SUBJECT: Initial Drafts of Revisions to MIL-DTL-38999/32D and MIL-DTL-38999/33D  
(Connectors, electrical, circular, cover), Project Numbers 5935-4666 and 5935-4665.

MIL-DTL-38999/32D  
 NOT DATED  
 SUPERSEDING  
 MIL-DTL-38999/32C  
 AMENDMENT 1  
 7 February 2003

CONNECTOR, ELECTRICAL CIRCULAR, COVER,  
 PROTECTIVE, PLUG, SERIES III, METRIC

FIGURE 1. Protective cover, plug, all classes.

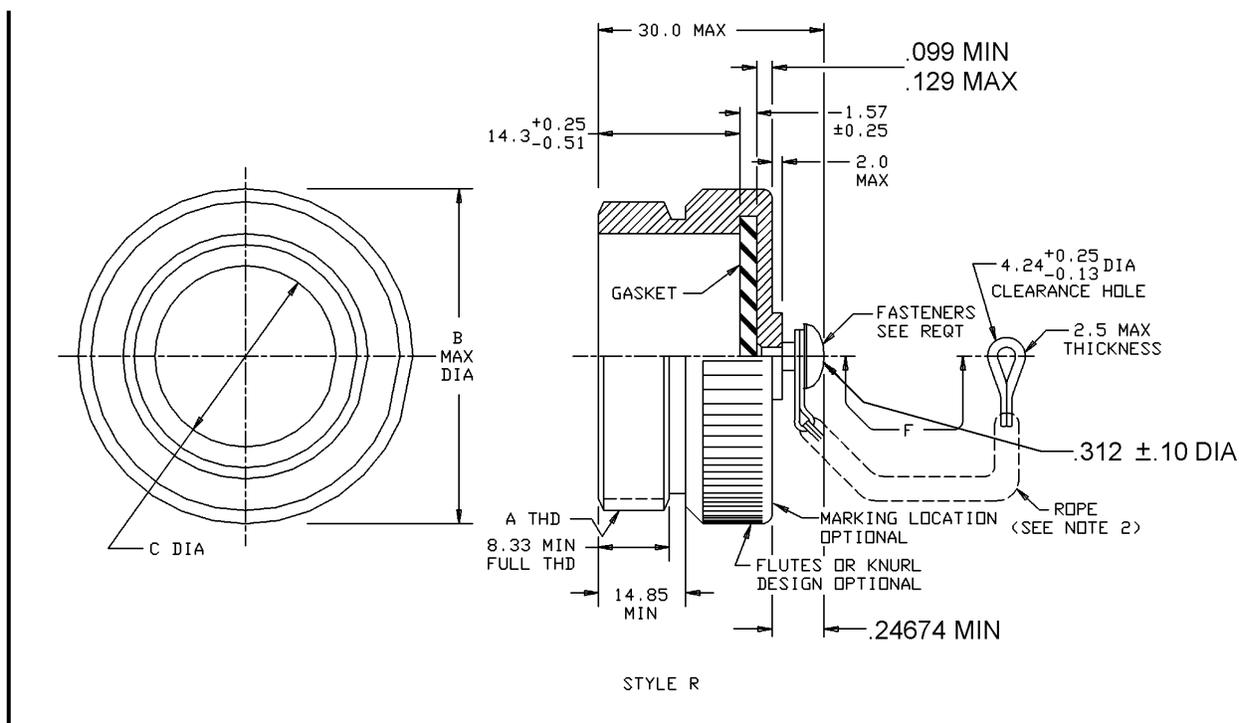
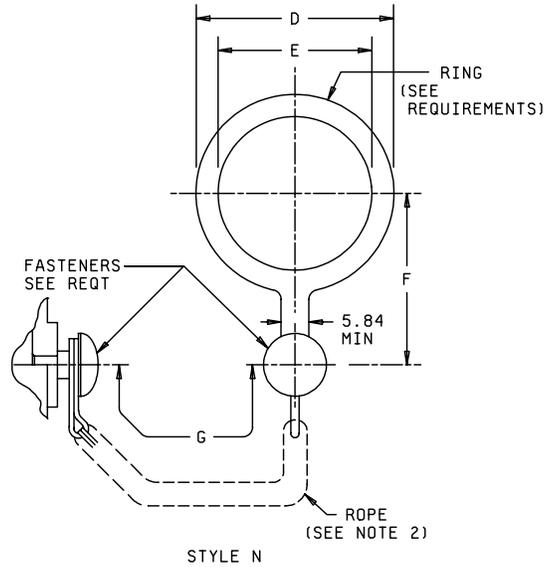
Page 1: Add Dimensional changes to figure 1.
